Appendix A2

2018 NOP and NOP Responses

NOTICE OF PREPARATION

Project Title: Proposed Code Amendments to Exception "P" of Title 15.20.040 (Landslide Moratorium Ordinance) of the Rancho Palos Verdes Municipal Code pertaining to Zone 2

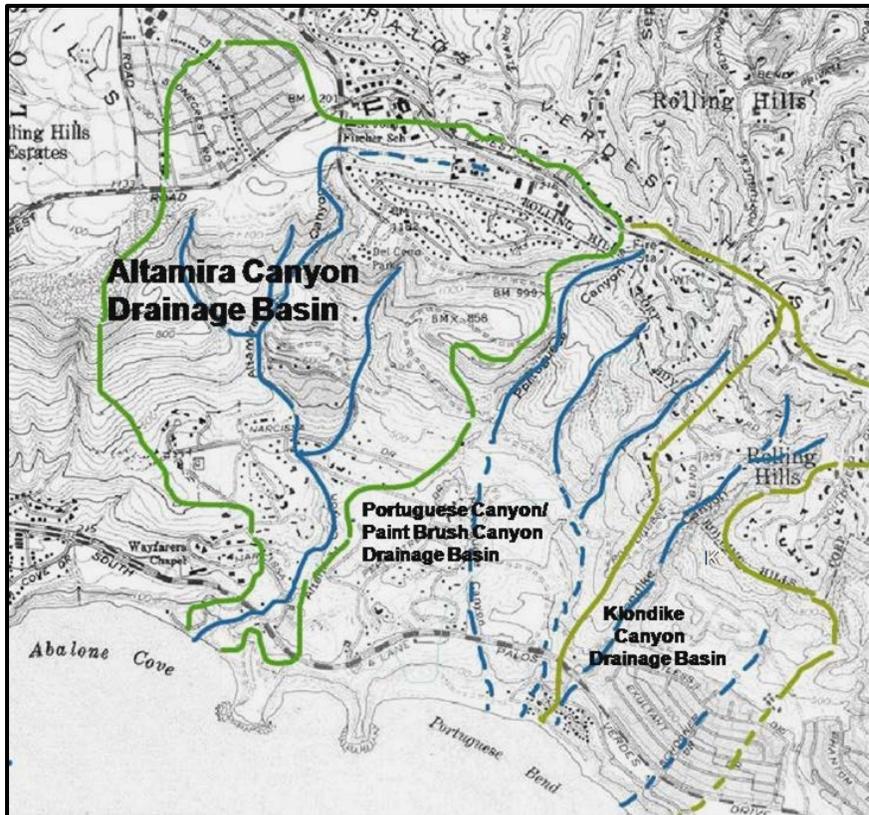
- 4) The EIR is using this distinction of Zone 2 as its scope based upon the city dividing the larger PBLC into Moratorium zones. Yet the EIR acknowledges that the geology of Zone 2 and Zone 5 are connected within the larger Portuguese Bend Landslide Complex (PBLC) and that that the downhill Zone 5 is supporting the uphill project area of Zone 2. Geologist Bob Douglas confirms that “One of the problems in tracing the landslide from one location to another across the area is that there are very few distinctive beds that can be used to correlate from one borehole to another.”

The proposed project amendment to the Landslide Moratorium Ordinance applies to only one section of the PBLC. The separation of Zone 2 and Zone 5 is a man-made delineation and is based upon one activation of one area of the larger PBLC. Dewatering wells in the project area of Zone 2 have help stabilize areas for the moment in both Zone 2 and Zone 5 as evidenced by the GPS monitoring. But any geologist will tell you that this is an ongoing story and that the Abalone Cove Landslide could migrate uphill into the project area. The two areas are geologically and hydrologically connected.

By the EIR applying a development code to one area of the larger PBLC and not another is ignoring this fact and cannot be justified by merely setting the scope of the project area as Zone 2 alone.

**2019 ZONE 2 EIR REVISIONS:
INCLUDE 20 VANDERLIP;
ABILITY TO SPLIT LOT**

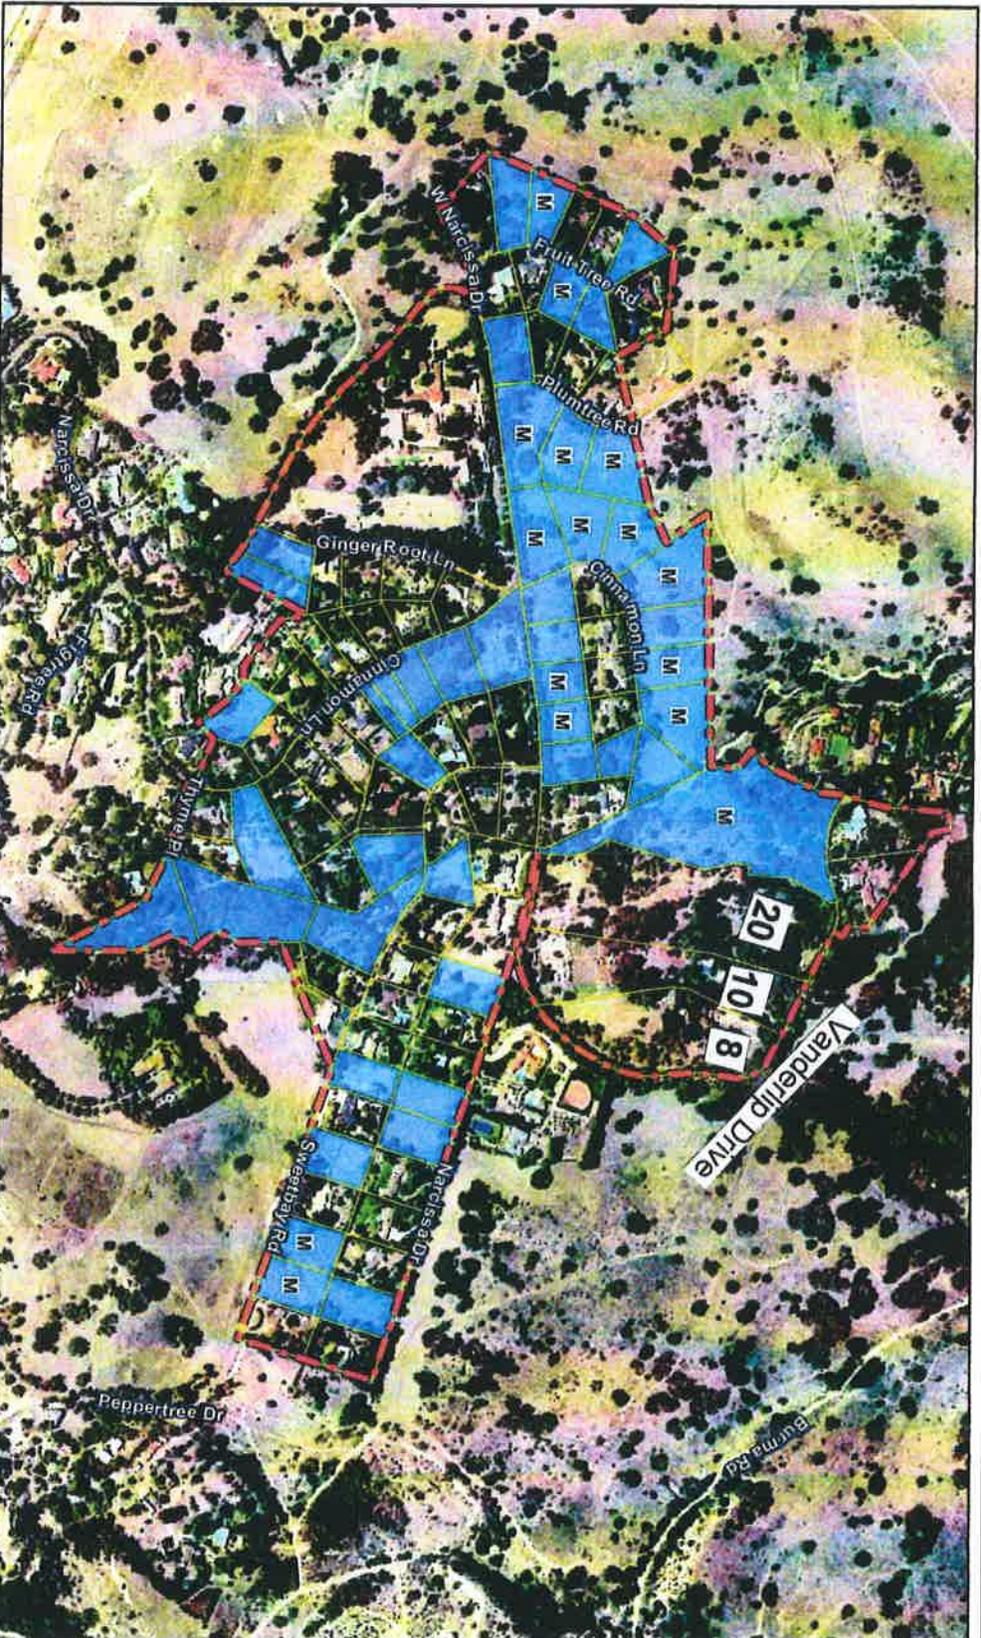
2. However, 3 lots are not included. Considerably larger than the 31, these have also waited 40 years to provide their owners full lot use, an ability to split their lots.
